UNITED STATES PATENT AND TRADEMARK OFFICE

APPLICATION NO.	FILING DATE	FIRST NAMED INVENTOR	ATTORNEY DOCKET NO.	CONFIRMATION NO.
09/923,720	08/06/2001	Frank Pietzschmann	2000P15141	1125

Office Action Summary

DETAILED ACTION

FIG. 1

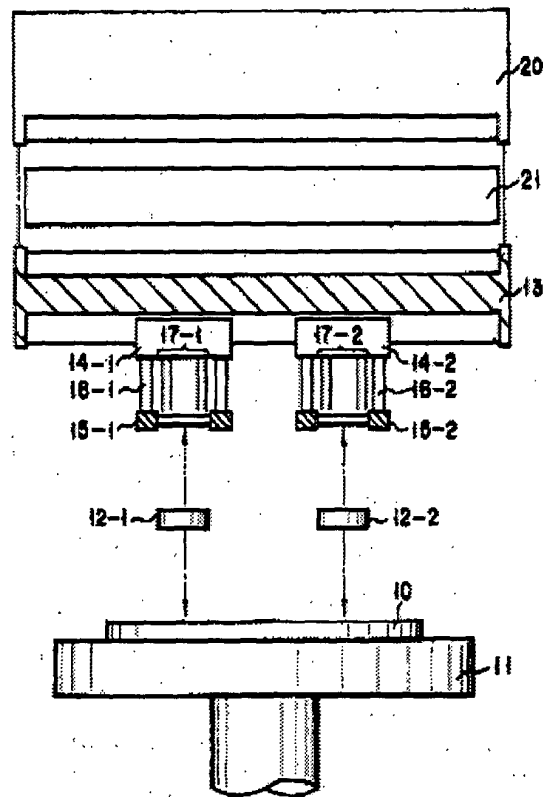
Hagihara '(192) in view of Itoyama ('053) do not teach that their probe card includes a plurality of partial cards that are separated from each other.

Momohara ('912) disclose probing equipment and expressly teach to include a plurality of partial cards that are separated from each other (see Fig. 1 below).

It would have been obvious to one of ordinary skill in the art at the time the invention was made to incorporate the teaching of Momohara ('912) 's plurality of partial cards into Hagihara ('192) 'probe card in view of Itoyama ('053) for the purpose of having a high processing ability at a low price disclosed by Momohara ('912) (see Col. 1, lins 66-67).

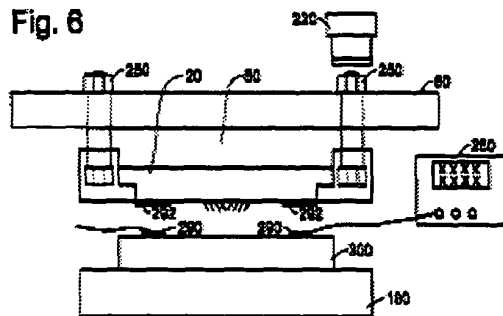
Hagihara '(192) in view of Itoyama ('053) do not teach that their probe card has a device for storing and outputting an identification number.

Nagasawa ('083) teaches a probe apparatus and expressly teach a probe card (21) has a device (ROMs 48) for storing and outputting an identification number (the serial number of a probe card).

It would have been obvious to one of ordinary skill in the art at the time the invention was made to incorporated the teaching of Nagasawa ('083)'s device for storing and outputting an identification number and for applying coordinated signals to the wafer into Hagihara '(192) 'probe card in view of Itoyama ('053) for the purpose of avoiding collision between the probe card and semiconductor disclosed by Nagasawa ('083)(see abstract).
